MEMORANDUM

RE: Response to Comments on NOI for DEP #CE 204-0991, The Reconstruction of Foster Street in Littleton, MA

RE: Stormwater Analysis
Reconstruction of Foster Street Project (MassDOT Project #609054)
MassDEP File #204-0991

CONTINUED ON
SHEET NO. 71

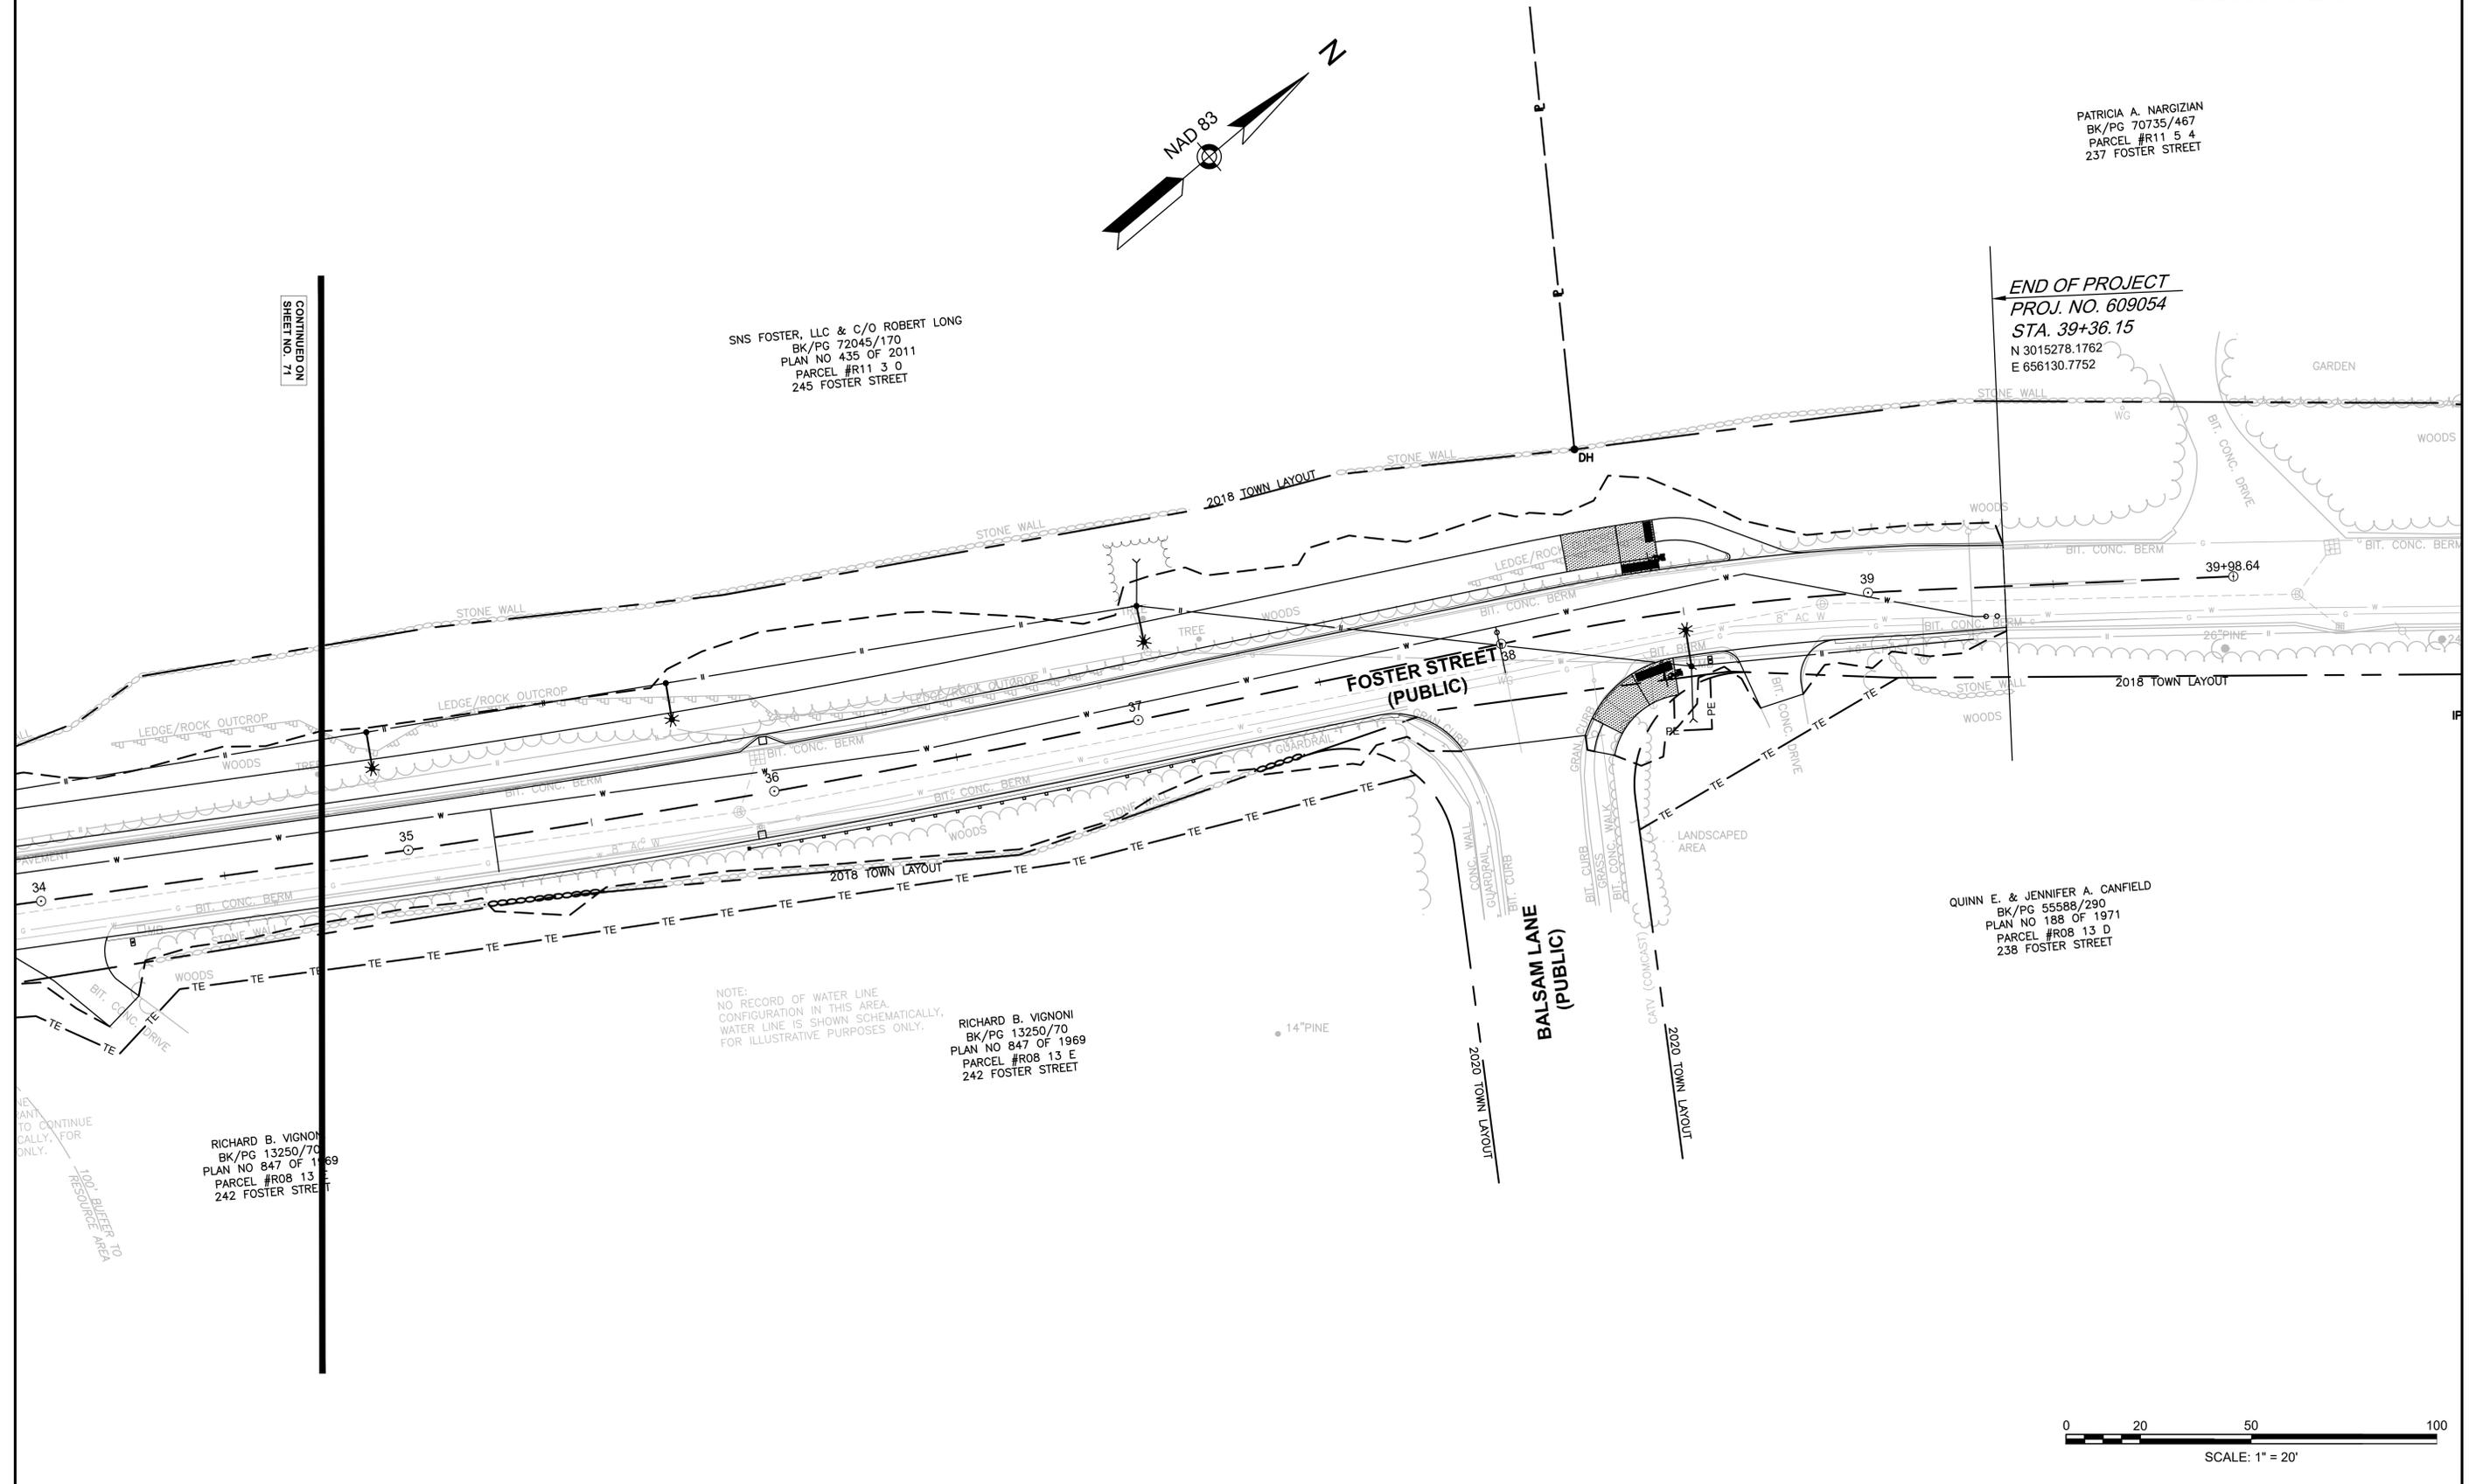
- Commissioners requested a tree inventory of trees to be taken at the 260 Foster St parcel including station, size, and species. A commissioner stated a replacement ratio of 2:1 was advised. Older and larger trees should be replaced at a higher ratio. Commissioners noted that trees likely to die as the result of the work (e.g., due to backfill around the tree base) need to be considered as tree removals.

F&O Response #6: F&O created a tree inventory in the 100-foot Buffer Zone listing trees that will be impacted from slope construction. The inventory lists proposed replacement tree quantities and species and is included in Attachment 5. The proposed tree replacement ratio is 2:1. The replacement trees were selected from the Town of Littleton Tree Guidelines document. New planting plan sheets showing the location of proposed tree replacements are also included in Attachment 5.
